AGENDA
Design Review Committee
November 8, 2023 – REGULAR MEETING

Town of Jackson Design Guidelines Checklist

Item Number: P23-175

Response to Town of Jackson DRC Comments dated 2023 September 26

EAST BUILDING - PREVIOUS APPROVED DRC RENDERING

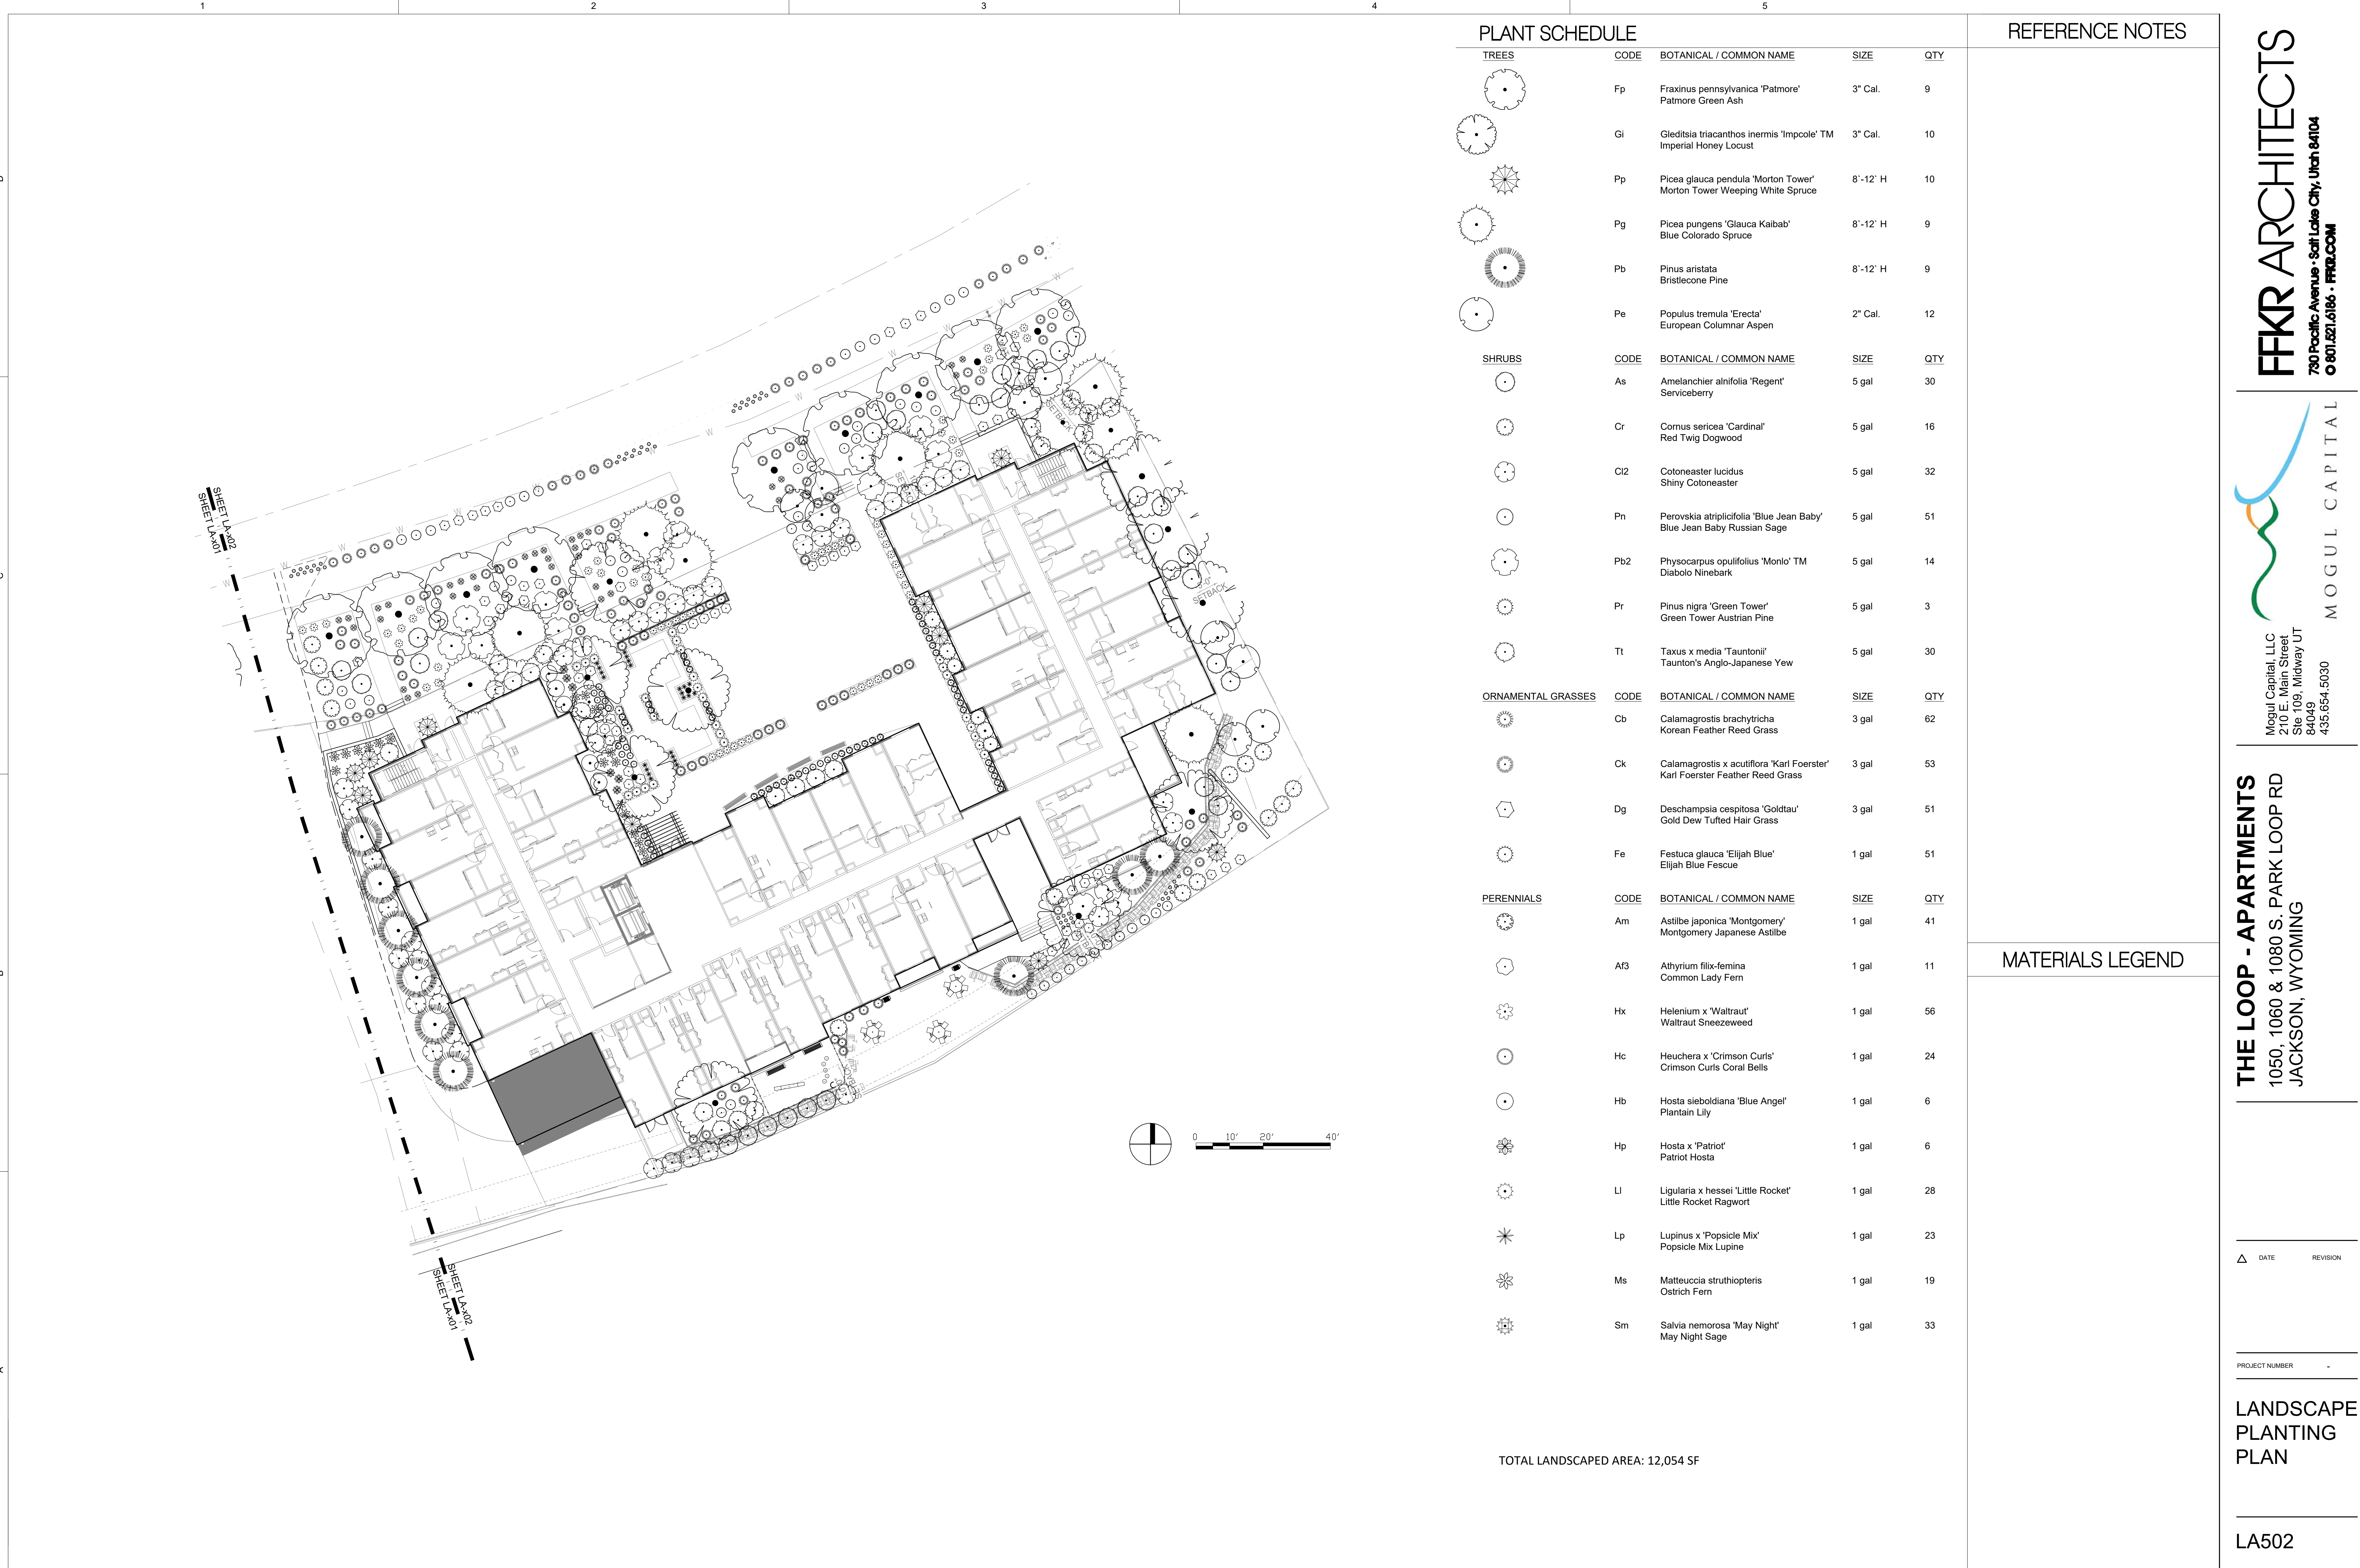
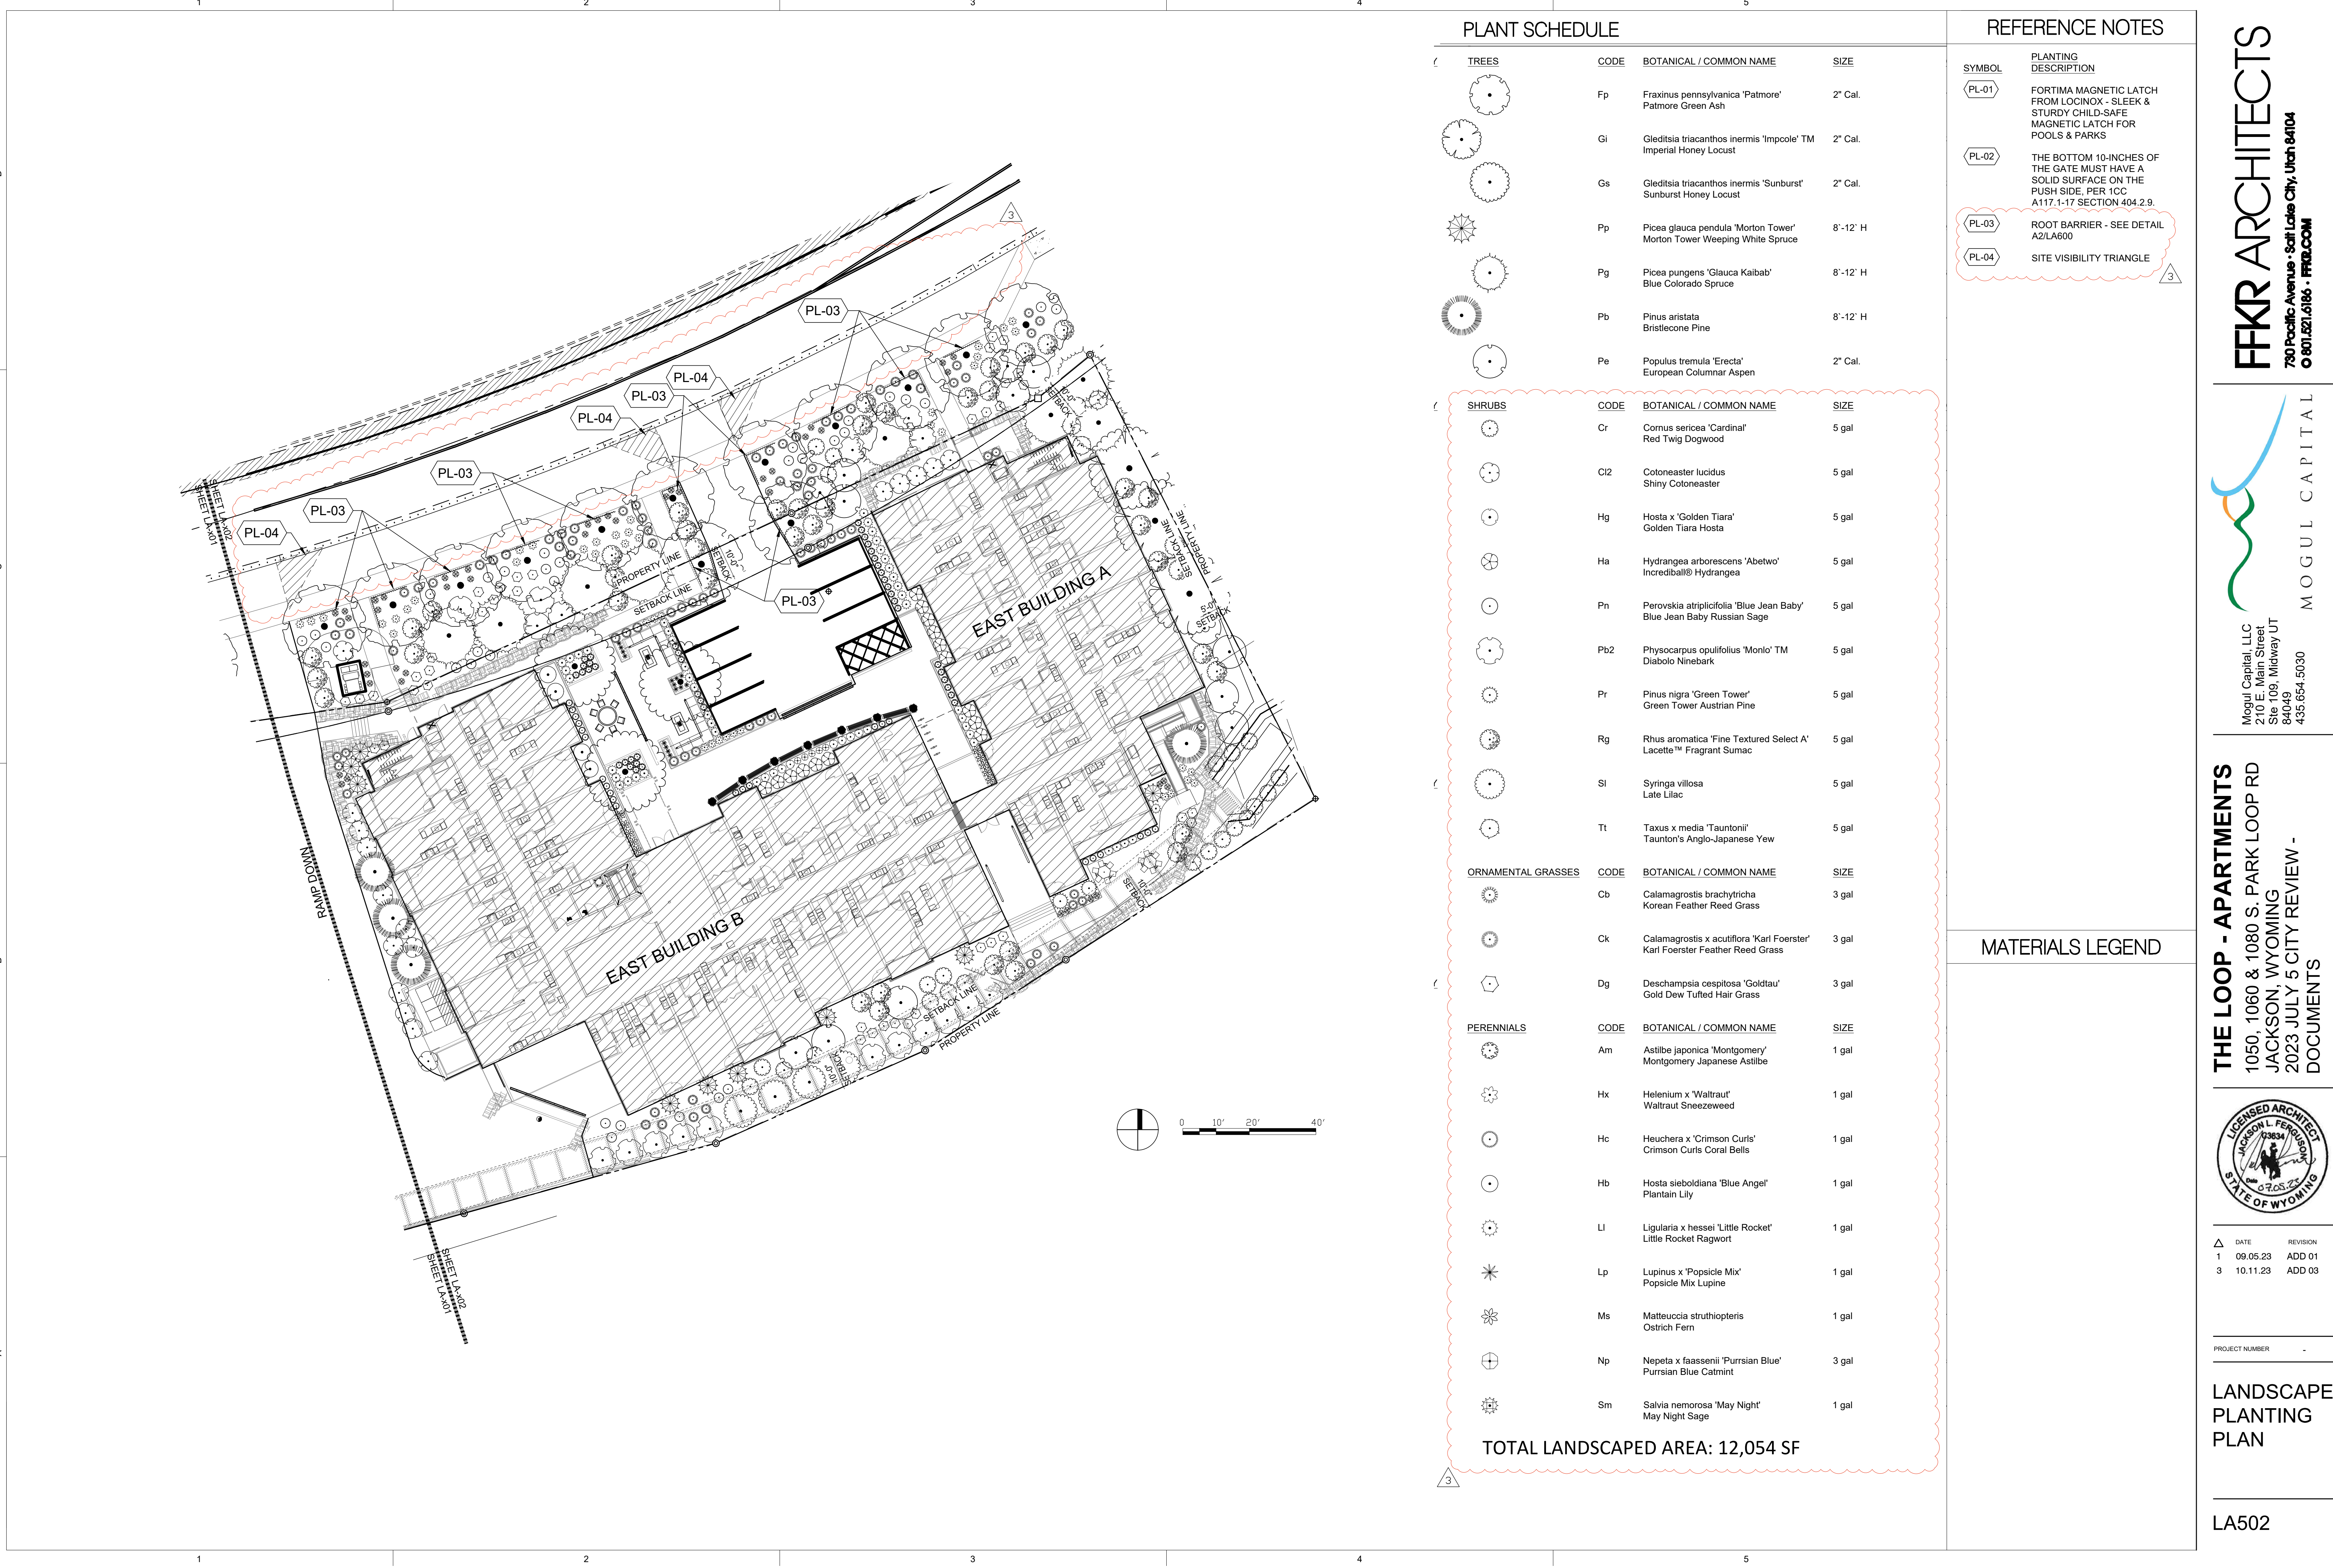
Staff note – The applicant is proposing changes to the approved courtyard landscape plan. The major difference is that there appear to be +/-10 fewer trees in the west courtyard and 2 fewer trees in the east courtyard. In general, the number of shrubs and perennials in both courtyards is comparable.

In addition, there's been some unintentional misinformation regarding the amount of approved sod. In the approved plan below, and all approved 3D renderings, the green areas represented sod and designated areas for planting trees, shrubs, and perennials. However, the applicant has stated that their intent all along was to have rock mulch instead of sod based on the high quantity of ground-covering shrubs and perennials. Mulch is a permitted landscape material, however, the Town does not allow mulch as the primary landscape material. Based on the approved plans, the Town is expecting sod to be placed throughout the site but would allow mulch in certain areas, especially areas with dense shrubs and perennials. Staff is seeking the DRC's feedback on this topic.
